DRAFT
FIFTH EXPLANATION OF SIGNIFICANT DIFFERENCES (ESD)
FOR THE
NEW BEDFORD HARBOR SUPERFUND SITE
UPPER AND LOWER HARBOR OPERABLE UNIT 1 (OU1)
NEW BEDFORD, MASSACHUSETTS
APRIL 2015

EPA REGION 1

New Bedford Harbor Superfund Site (Site)
Upper and Lower Harbor Operable Unit 1 (OU1)
Bristol County, Massachusetts

Figure 21a - Conceptual locations of upper harbor CDFs A, B and C
 New Bedford Harbor Superfund Site, ROD 2

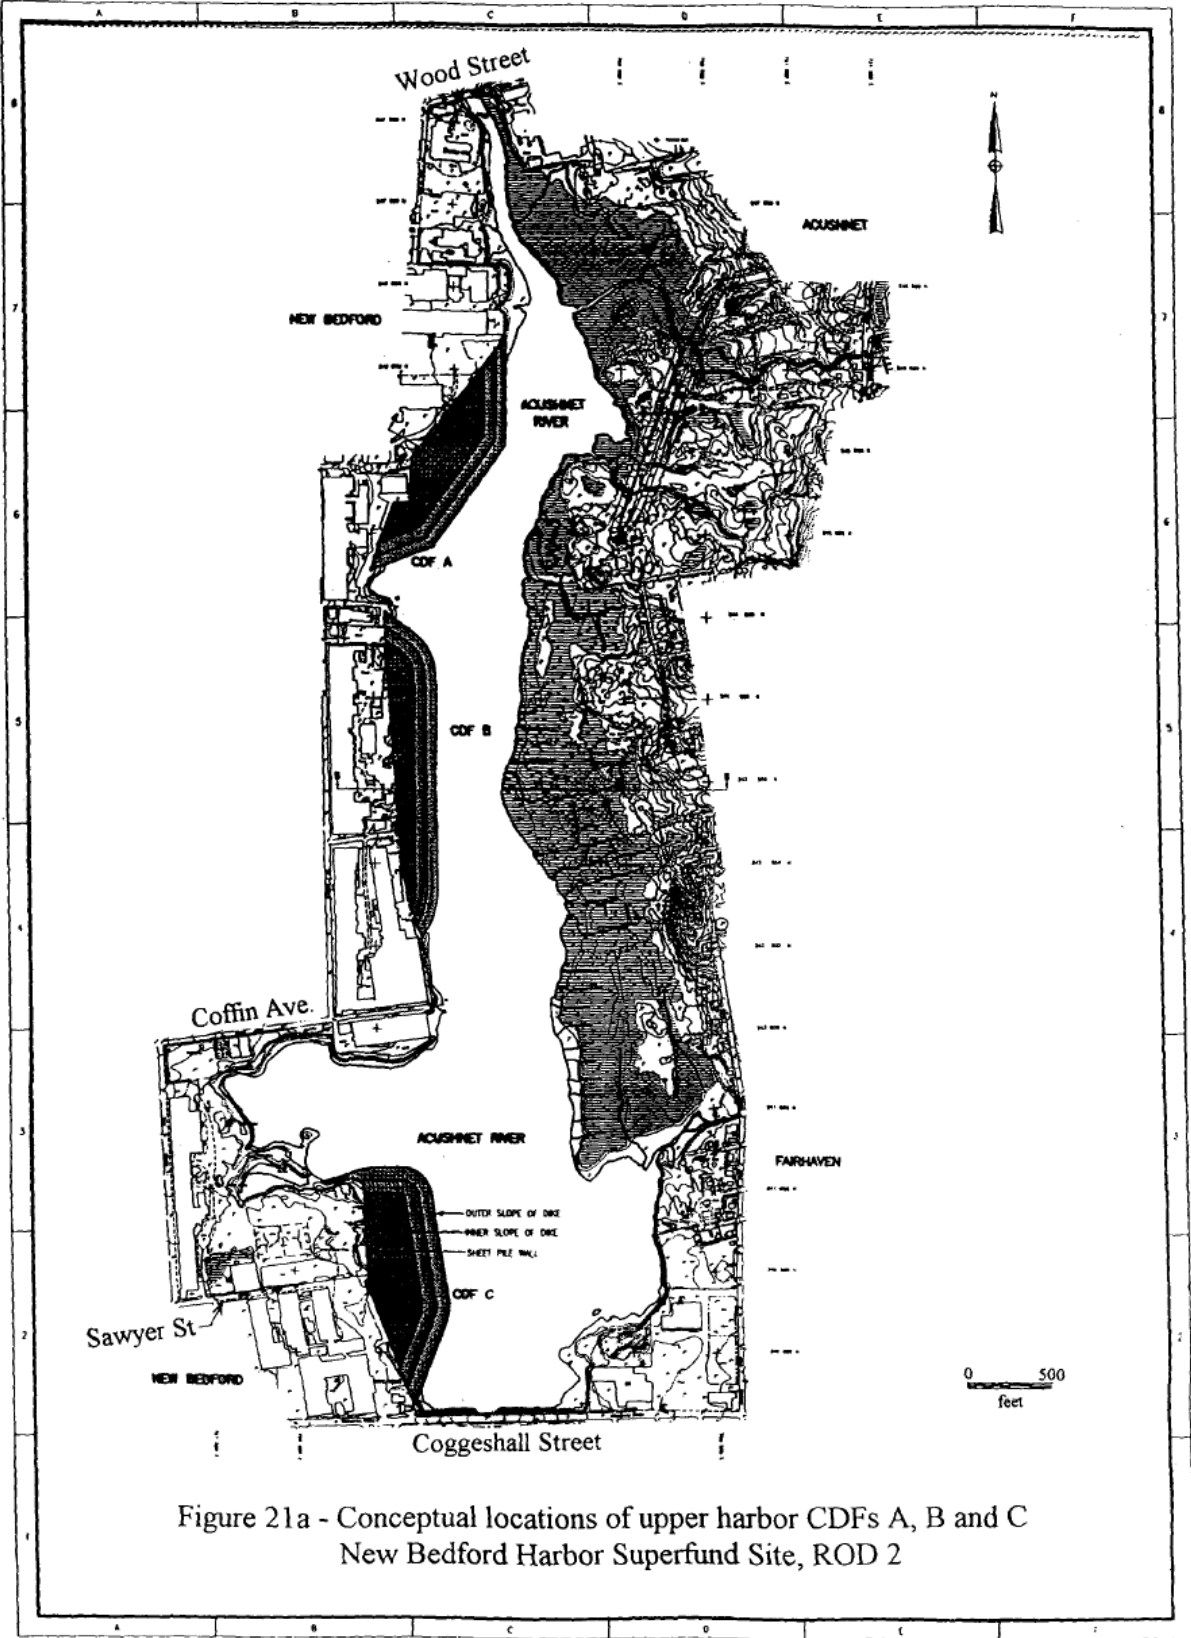
Through this draft fifth ESD to the OU1 ROD, EPA is proposing to modify the remedy for the Upper and Lower Harbor by eliminating the construction of the planned CDFs A, B and modified-C and selecting off-site disposal for the sediment slated for disposal in those planned confined disposal facilities. As conceptually planned under the OU1 ROD, CDFs A, B and C were to be shoreline structures (see attached Figure 21a from the OU1 ROD). Note that CDF C was planned for construction at and around the location of the pilot study CDF (see discussion in Section II.A, below, regarding the creation and use of the pilot study CDF). As such, the Pilot CDF is located within the footprint of the conceptual location of CDF C.

Considering the potential effectiveness and implementability concerns associated with CDFs, the longer timeframe needed for CDF construction and utilization, and the higher estimated cost of CDF disposal as compared to off-site disposal, EPA proposes, through this draft ESD, to eliminate CDFs A, B and modified-C as a disposal element of the OU1 remedy and instead select off-site disposal for the approximately 175,000 cubic yards on *in situ* contaminated sediment currently slated to be disposed of in CDFs A, B and modified-C.

Figure 2-1 Confined Disposal Facility

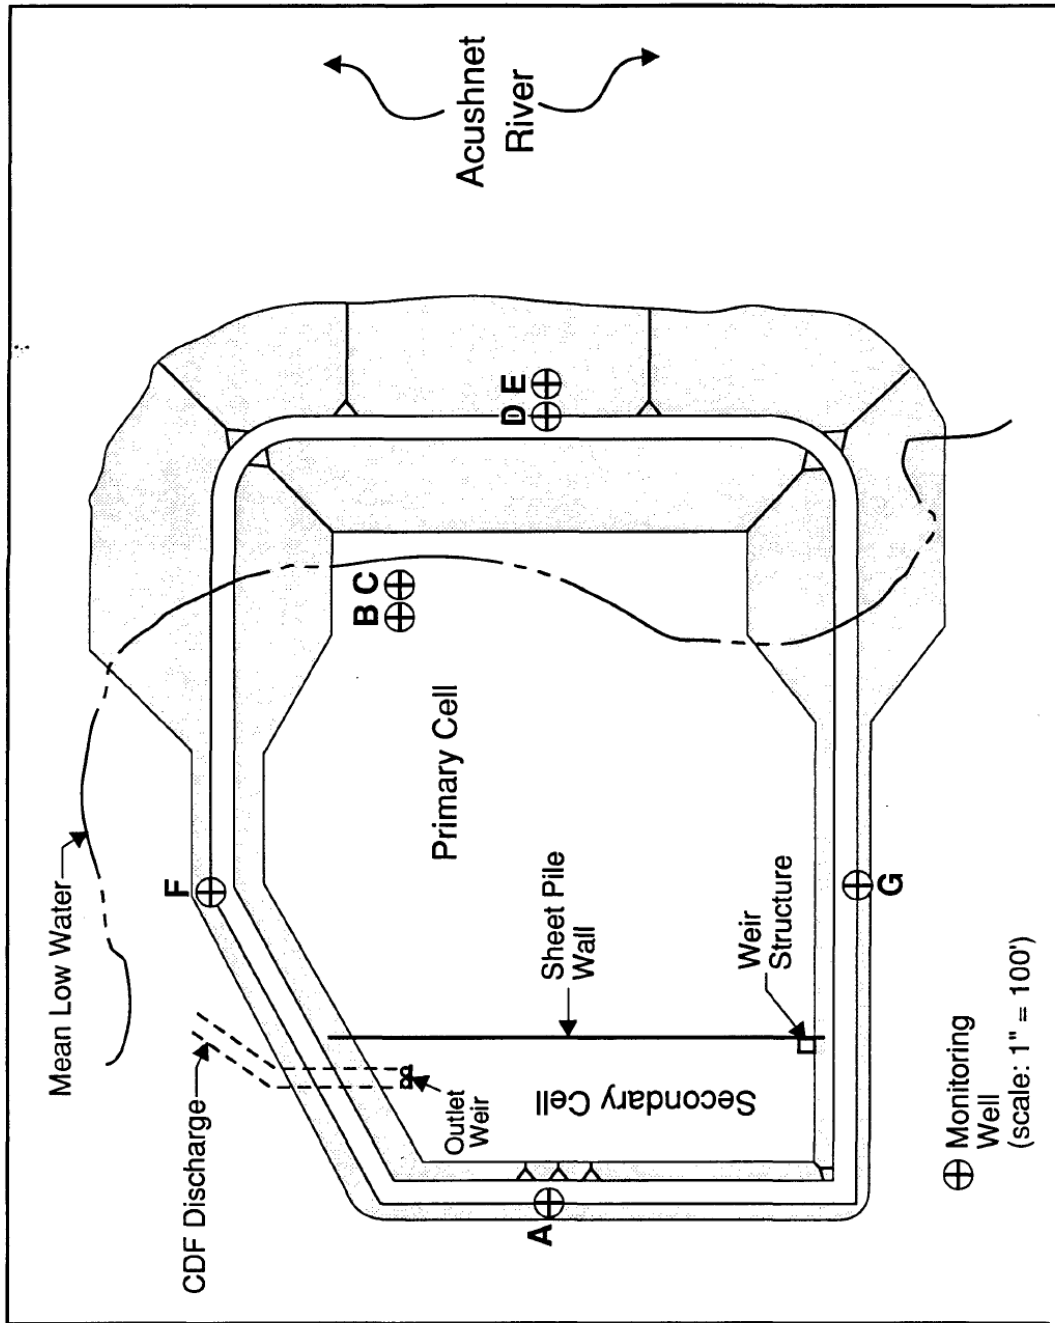
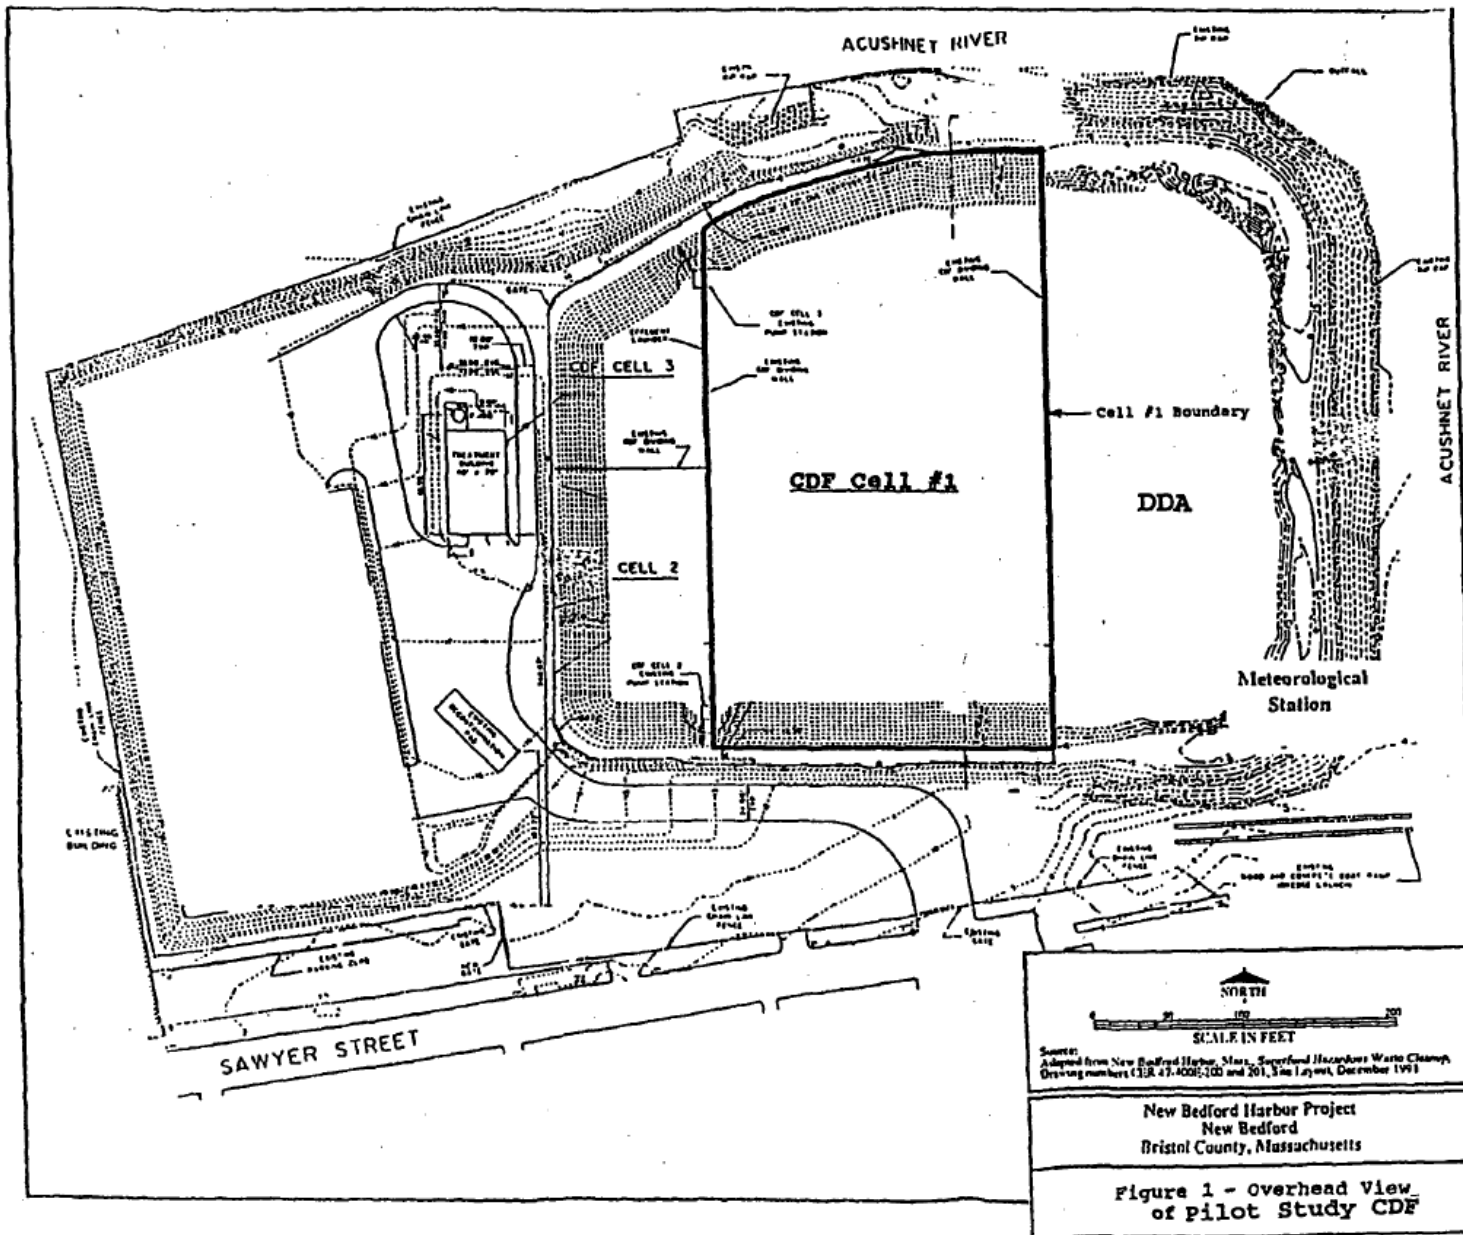
Groundwater and air monitoring performed at the Pilot CDF since 1992, along with groundwater modeling, demonstrate that PCBs are not migrating from the Pilot CDF area. See attached Figure 1 from the Sawyer Street Semi-annual Groundwater Monitoring Technical Memorandum showing location of groundwater monitoring wells. As noted in ESD1, underlying the Pilot CDF is a clay layer sandwiched between the Pilot CDF contents and the underlying sands. The clay layer acts as a naturally impermeable barrier to the movement of contaminants from the area. The constructed dike serves as three sidewalls of the Pilot CDF. Due to the type and quantity of materials used to construct the dike, these sidewalls have moderate permeability with an estimated hydraulic conductivity of 3 ft/day. Although these sidewalls are not impermeable, the over 20 years of groundwater monitoring data demonstrate that PCBs are not migrating. The sheet pile wall that serves as the sidewall separating the Pilot CDF from Cell #1 is impermeable. Consistent with the process described in ESD1, since the monitoring and modeling performed to date of the Pilot CDF confirm that PCBs are not migrating from the area and given the subsurface and sidewall features, EPA intends to make the Pilot CDF an element of the final remedy.
